**Subject: Diversion of 151.095 ha forest land including 142.075 ha forest land in Forest Compartment No. RF-827 & RF-828 of Burhar Range of South Shahdol Forest Division and 9.020 ha Revenue forest land under various Khasra's for Bikram Coal Block Open cast & underground Coal Mining Project in favour of M/s Birla Corporation Limited under Shahdol District of Madhya Pradesh State (Online No. FP/MP/MIN/49537/2020) – regarding.**

**Proposal: - Diversion of 151.095 ha forest land for Bikram Coal Mine of M/s Birla Corporation Limited**

**Observations on the new CA site at Village: Barha, Majhgawa Tehsil, Satna District:**

Google imagery showing the newly proposed CA land at Village: **Barha, Majhgawa Tehsil, Satna District**

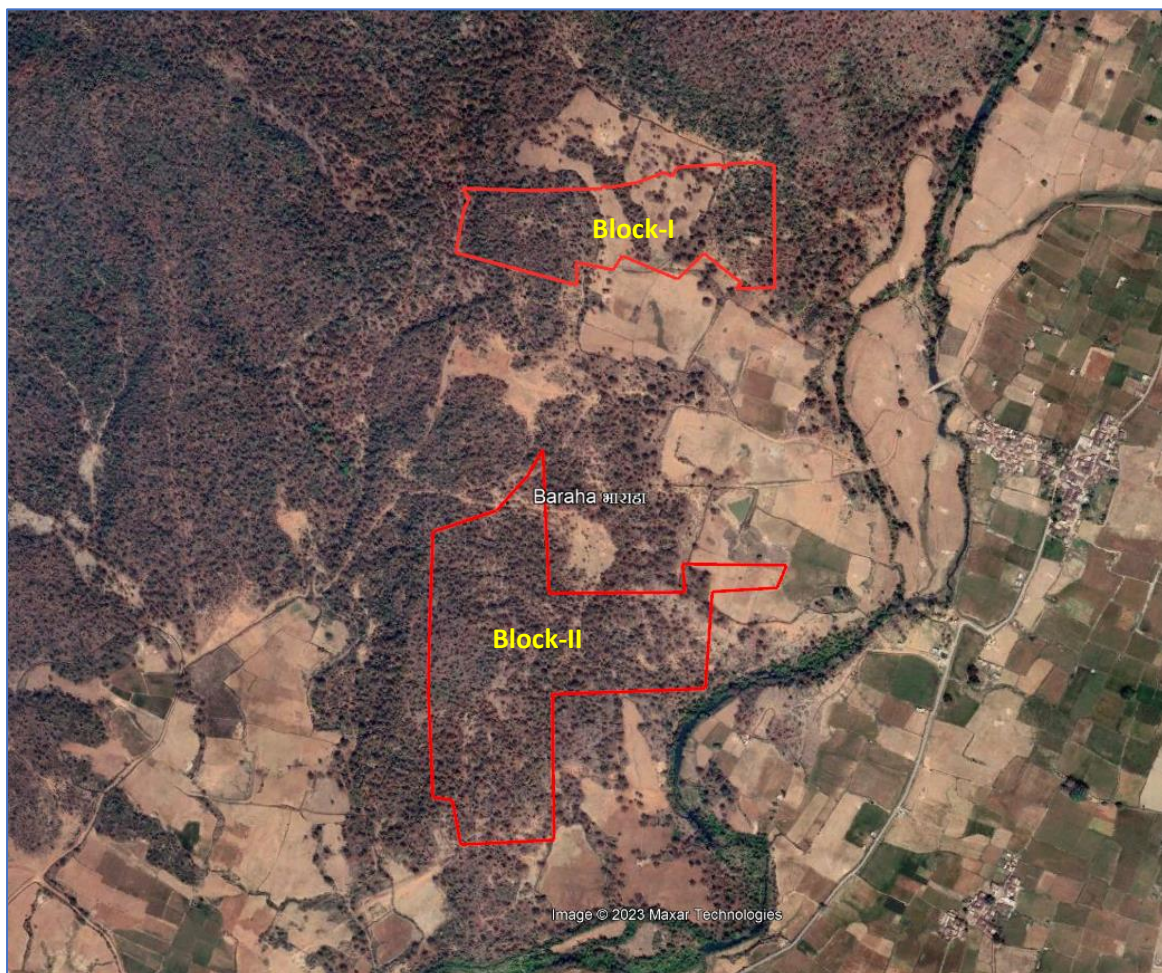
- a) Total area of newly proposed CA land is found 36.0481 ha instead of 36.185 ha as reported by the State Govt.
- b) The DGPS map & Survey of India (SoI) Toposheet Map showing the newly proposed CA site is not given. Hence, the State Govt. may be requested to provide the same.
- c) **Forest Cover: Out of 36 ha (DSS Calculated)** 35 ha of land is characterized with Moderately Dense Forest and 1 ha is Non Forest (Non-wooded) in terms of forest classes (as per the ISFR 2019) based on the interpretation of satellite data period 2017-2018.
- d) As per DSS, part of proposed CA land is falling in the forest land i.e. Range: Barondha, Compartment No. 147 of Satna Forest Division. The State Govt. may be requested to verify the legal status of proposed CA land.
- e) The State Govt. may be requested to provide the cadastral map of newly proposed CA land.

**DSS Map showing the part of proposed CA land is falling in the Forest land**

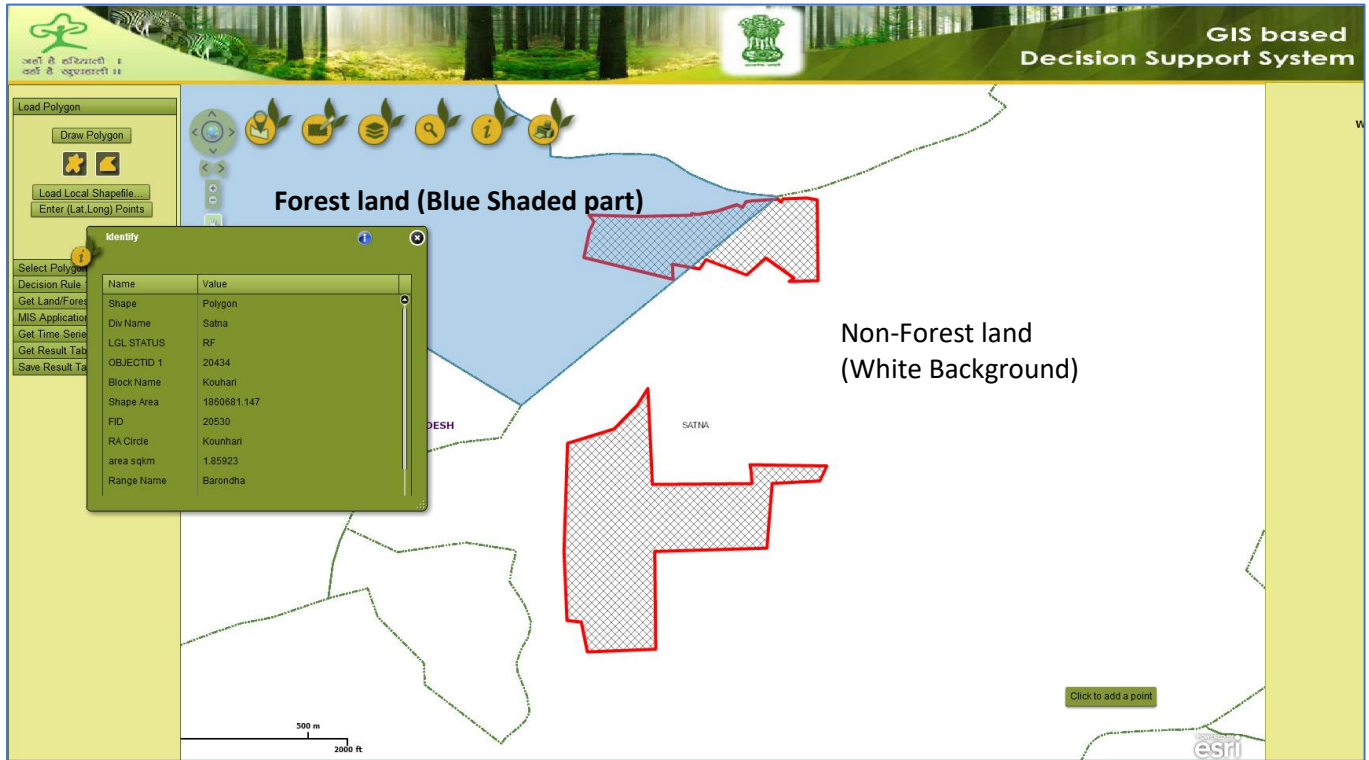
- iv. DGPS map & Survey of India (Sol) Toposheet Map showing the newly proposed CA site shall be submitted.
- v. As per DSS analysis(Copy enclosed), part of proposed CA land is falling in the forest land i.e. Range: Barondha, Compartment No. 147 of Satna Forest Division. This needs to be verified through ground truthing and relevant record.
